- 3. Big Bear Lookout Subdivision; KPB File 2025-110**
AK Lands / Chmielowiec
Location: Holt Lamplight Road & De Busk Drive
Nikiski Area / Nikiski APC

**ITEM #3 - PRELIMINARY PLAT
BIG BEAR LOOKOUT SUBDIVISION**

KPB File No.	2025-110
Plat Committee Meeting:	September 8, 2025
Applicant / Owner:	Susie Chmielowiec of Houston, Texas
Surveyor:	Stacy Wessel / AK Lands Land Surveying
General Location:	Holt Lamplight Road and De Busk Drive, Nikiski

BIG BEAR LOOKOUT SUBDIVISION

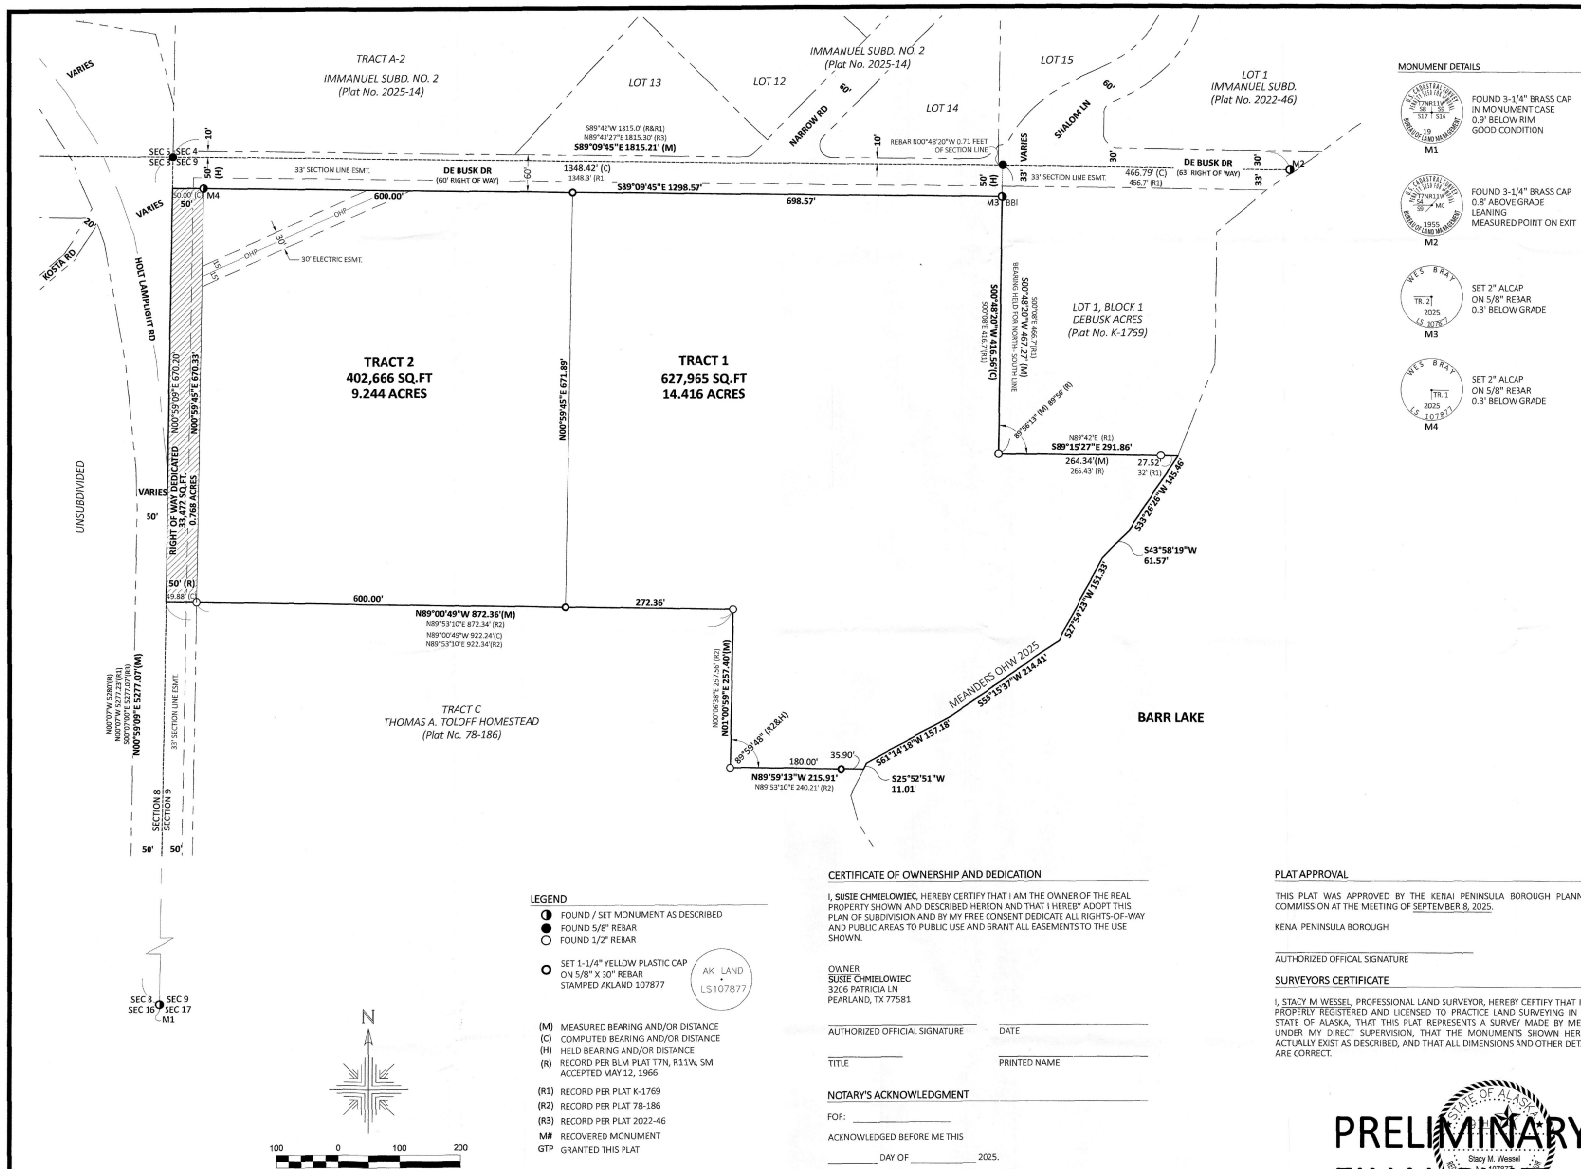
KPB Roads Dept RSA review	Out of Jurisdiction: No Roads Director: Uhlin, Dil Comments: No comments
SOA DOT comments	Section corner numbers are flipped on the M1 monument corner. Since Holt-Lamplight is a DOT road, we can accept the dedication for that portion.
SOA DOT&PF	No direct access to Holt Lamplight will be granted. All proposed lots must take access from De Busk Drive.

- Modify KPB File Number to 2025-110

- The borough will not enforce private covenants, easements, or deed restrictions per KPB 20.60.170(B).
- Acceptance of this plat by the Borough does not indicate acceptance of any encroachments.
- No access to state maintained rights-of-way permitted unless approved by the State of Alaska Department of Transportation.

- KPB Records show owner's address as 6002 Clinton Drive, Houston, TX 77020. Owner of record must confirm alternative address.

- Add labels: Kivi Lake in Section 5 and Georgina Lake in Section 4
- Add labels for the following sections: 6, 7, 31, 32, 33, 34

- Add CTP item #10
- Add the ROW easement recorded in Book 33, Page 39 as a plat note and include a statement that the plat is dedicating that portion of the easement.

- Add the ROW easement recorded in Book 33, Page 39 Include a flag label on the sketch.
- Extend the ROW dedication north to the section corner including the 50'x50' section that De Busk Acres (KN 1769) excluded.
- Existing gravel road on north for De Busk Drive encroaches onto subject parcel. Request additional ROW dedication south of current dedication.

- G. The status of adjacent lands within 100 feet of the proposed subdivision boundary or the land status across from any dedicated rights-of-way that adjoin the proposed subdivision boundary, including names of subdivisions, lot lines, block numbers, lot numbers, rights-of-way; or an indication that the adjacent land is not subdivided;
Staff recommendation:
○ Modify the subdivision label to the north: Tracts B&C Thomas A. Toloff Homestead (KN 78-186)

- N. Apparent encroachments, with a statement indicating how the encroachments will be resolved prior to final plat approval;
Staff recommendation:
○ Existing gravel road on north for De Busk Drive encroaches onto subject parcel. Request additional ROW dedication from west intersection to projection of the easterly line of Narrow Road. see contours map for encroachments and aerial map. **Staff recommends** the surveyor contact Platting Department staff for additional 30-feet from centerline ROW dedications.
○ Driveway for adjacent parcel to the east connects to existing road on northeast of parcel. Needs to be addressed.

Staff recommends the surveyor include a dedication of Holt Lamplight to the SOA
